Conway Planning Commission Staff Report

7:00pm • March 18, 2019 • 810 Parkway Avenue

I.A REQUEST FOR PRELIMINARY PLAT APPROVAL - VILLAGE AT HENDRIX, PHASE III

CITY OF CONWAY PLANNING & DEVELOPMENT DEPARTMENT REVIEW OF VILLAGE AT HENDRIX, PHASE III PRELIMINARY PLAT

The Village at Hendrix - Phase III, Replat of Lot 3, The Village at Hendrix - Phase II, Replat of Lot 1 of Hendrix Athletics Subdivision Conway, Arkansas

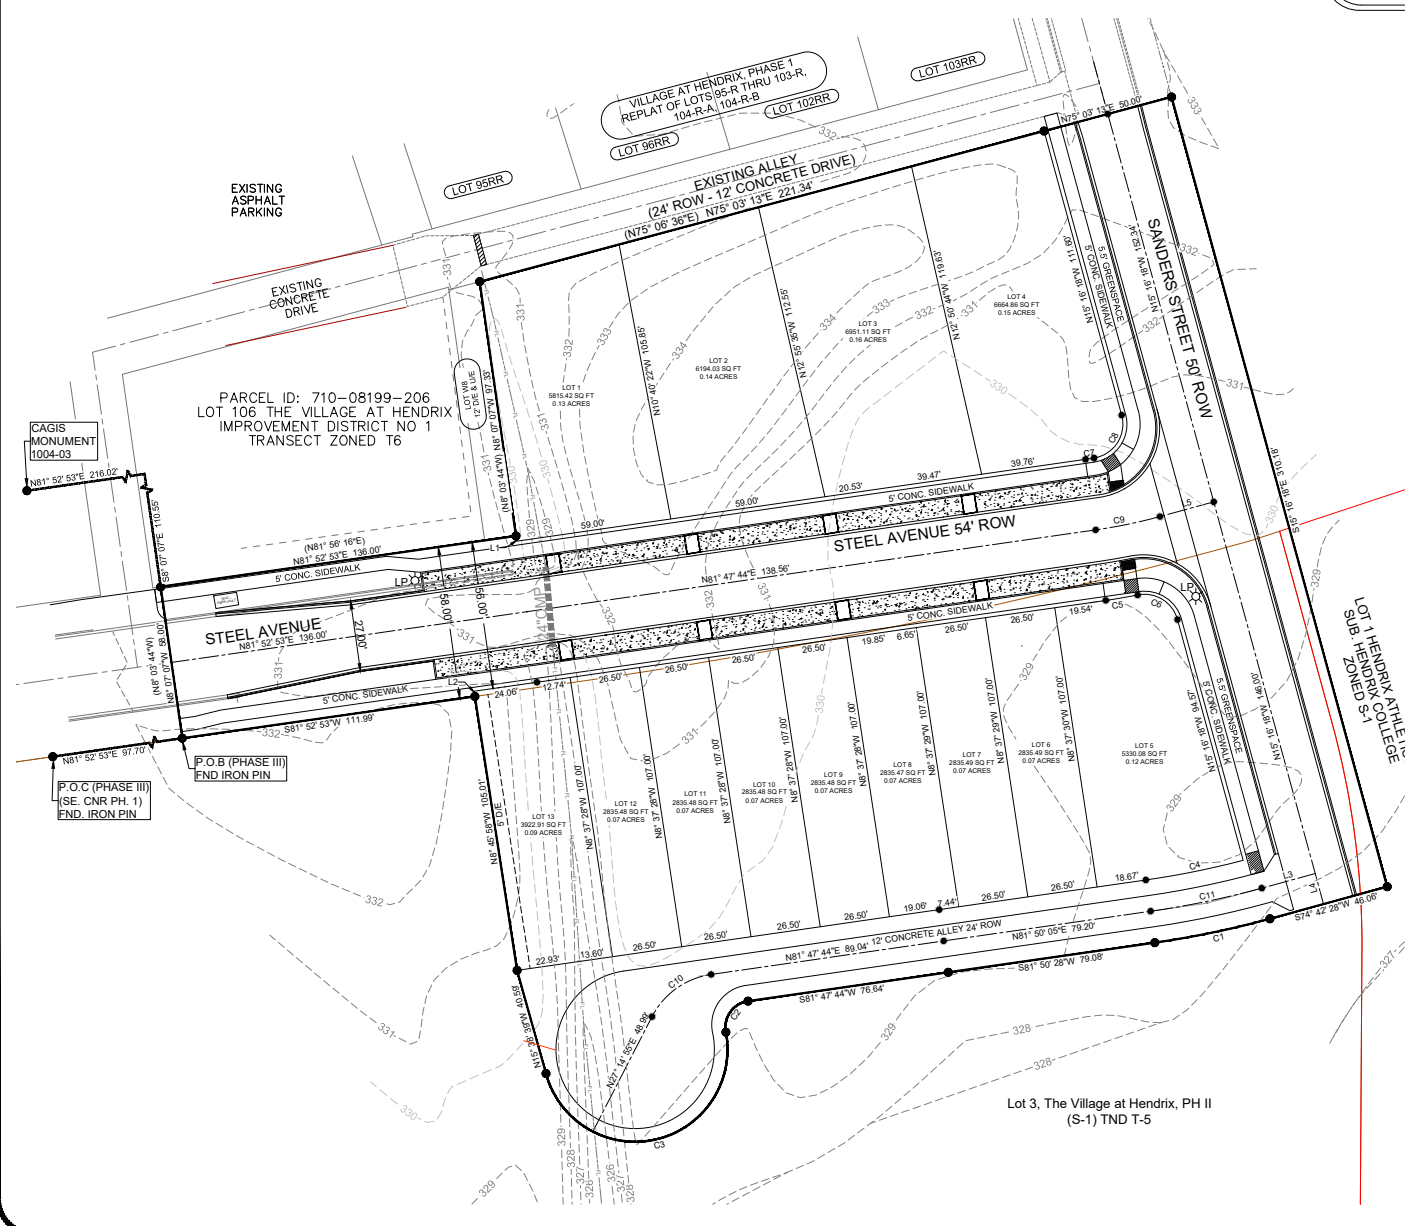
1. Add Planning Commission Chairman.
2. Correct the zoning on plat.
3. Correct right of way and cross sections. Label and dimension all sidewalks and planting strip in accordance with the Village at Hendrix TND.
4. Show all hydrant locations.
5. Correct the setbacks listed on the plat.
6. Correct the sidewalk notes on the plat.
7. Clarify symbols used for sidewalks, parking, and street pavement.
8. Add the following to general notes:
 - a. Every lot must slope to a street or drainage easement.
 - b. (A statement indicating the ratio error closure of the field work is needed.)

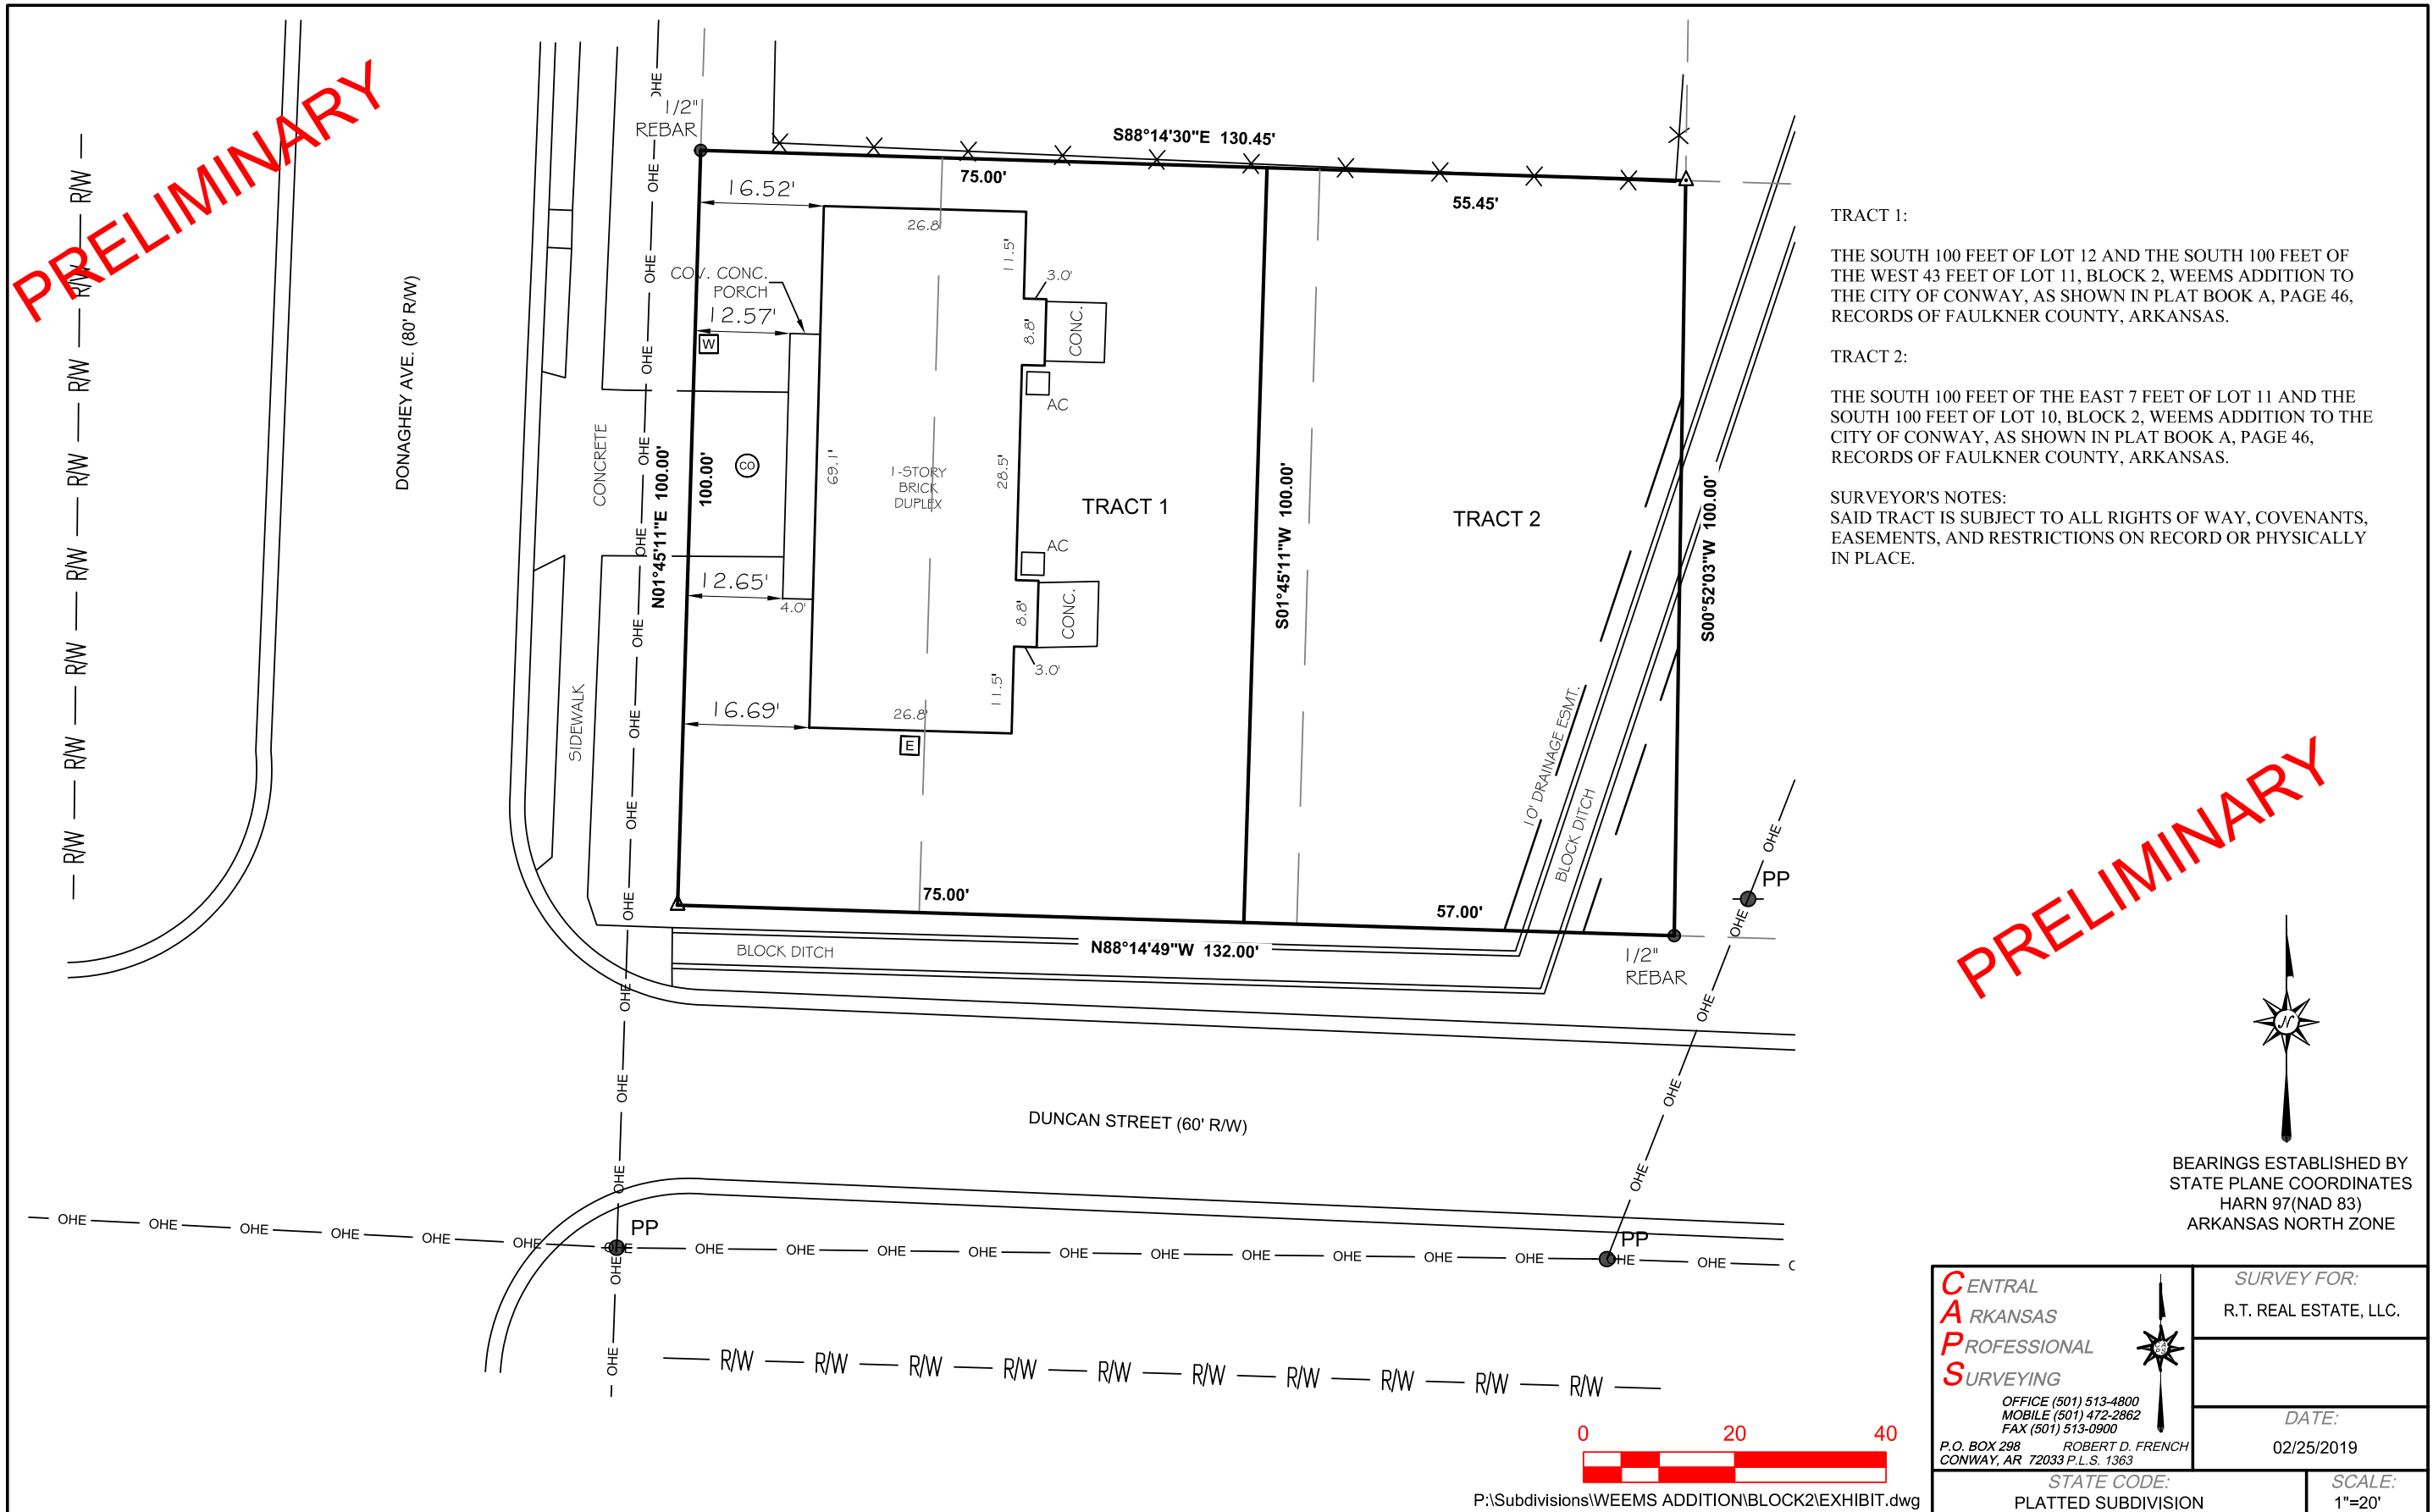
- Tract 1 (approx. 7500 sf) in the exhibit (p. 8) is proposed to be zoned R-2.
- Tract 2 (approx. 5500 sf) in the exhibit (p. 8) is proposed to be zoned HR.

- Upon replatting, Tract 1 may be required to dedicate additional right-of-way. However, it is anticipated Tract 1 will remain in compliance with R-2 area standards.

- A large concrete ditch runs through and along the property. The ditch will pose an obstacle to development for proposed Tract 2.
- The rezoning will not likely have any substantial negative impacts on adjacent property.
